ENCLOSURE 1 TO NLS-86-416

PROPOSED TECHNICAL SPECIFICATION PAGES

BRUNSWICK-1

Standby Liquid Control System Modifications

FIGURE 3.1.5-1

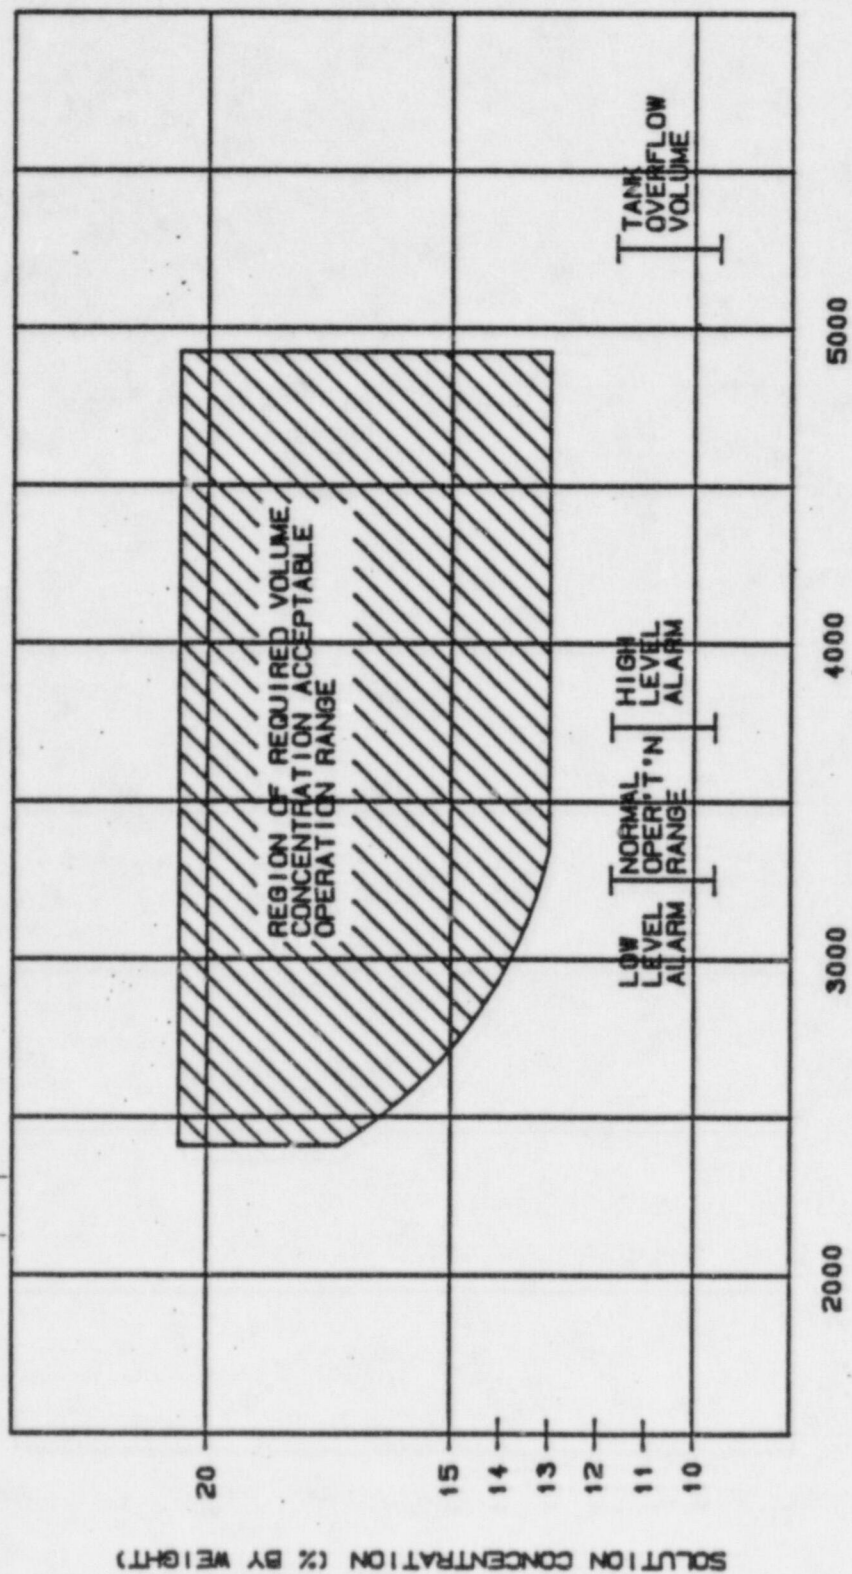
<u>PAGE NO.</u>	<u>DESCRIPTION OF CHANGE</u>
3/4 1 - 19	Revised Surveillance Requirement 4.1.5.c.2 to indicate that the minimum flow requirement of 41.2 gpm is a per pump requirement. Revised the pump relief valve setpoint in Surveillance Requirement 4.1.5.c.3.
3/4 1 - 20	Revised Figure 3.1.5-1 to indicate that the minimum allowable sodium pentaborate concentration is 13-weight percent.
